Executive Director's Recommendation

Commission Meeting: February 5, 2015

PROJECT**Tour Bridge Modernization Project**

Bureau of Engraving and Printing
310 14th Street, SW
Washington, DC

Figure 28: Existing condition showing people informally sitting on the low wall with guardrail on top

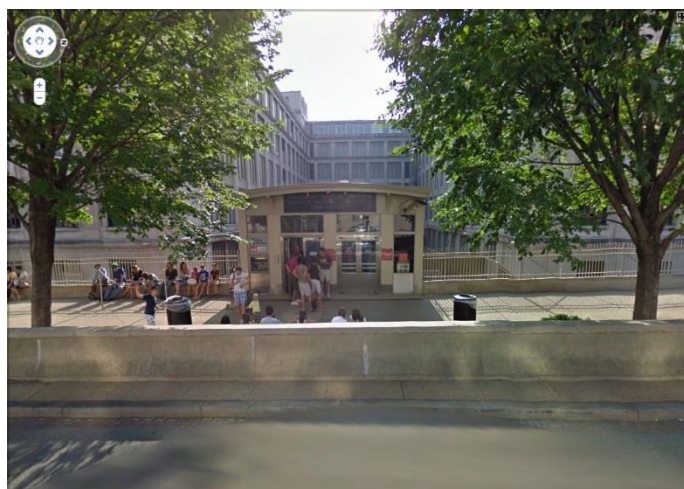
wall adjacent to the Tour Bridge entrance and queuing area creates an inefficient layout and conflicts with the architecture, resulting in awkward leftover spaces. Additionally, while reviewing some recent photographs, staff noted that during peak season, people informally sit on the edge of the existing low wall with guardrail that is located in front of the queuing area along 14th Street while waiting to enter the tour. This fact reinforces the need to provide adequate seating in this area. Therefore, **staff recommends to explore integrating seating into the design of the curved entry walls without creating queuing and circulation conflicts, such as a custom concrete cantilever bench along the curvilinear wall in lieu of proposed benches.** (Figure 28)

- Remove three bollards located perpendicular to the sidewalk along 14th Street SW to protect the public space by keeping it open, and accessible.
- Explore integrating seating into the design of the curved entry walls without creating queuing and circulation conflicts, such as a custom concrete cantilever bench along the curvilinear wall in lieu of proposed benches.

Figure 29: Historic drawings showing the bridge railing and column details

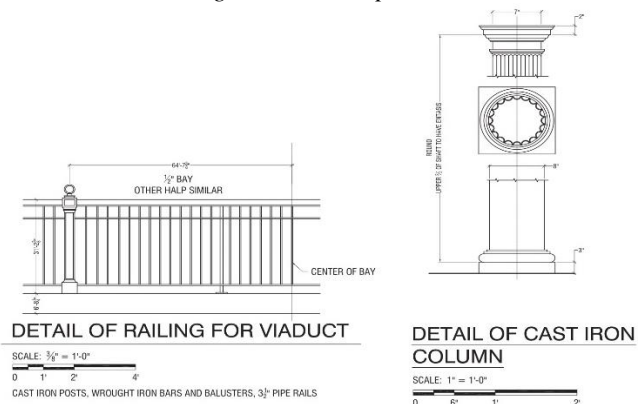
The proposal includes the partial elimination of the “Jersey” wall in front of the tour bridge entrance and features a bollard and pedestrian fence safety railing given the proximity to the 14th Street ramp along this heavily traveled road. The applicant is still considering several options for both the street side bollard and fence line and the guardrail on top of the curved wall. The fence should resemble the simplicity of the original 1914 bridge railing and cast iron columns, while the bollards should be compatible with the context. Therefore, **staff requests additional information before final review regarding detailed drawings about the size, spacing, material and style of the proposed fence/bollard configuration along the street side and guardrail on top of the curved entry wall.** (Figure 19, 29)

- Temporary (during construction) and permanent ADA accessible entrance and exit ensuring that people with disabilities are able to arrive on the site, approach the building, enter and exit as freely as everyone else.
- Detailed drawings about the size, spacing, material and style of the proposed fence/bollard configuration along the street side and guardrail on top of the curved entry wall.
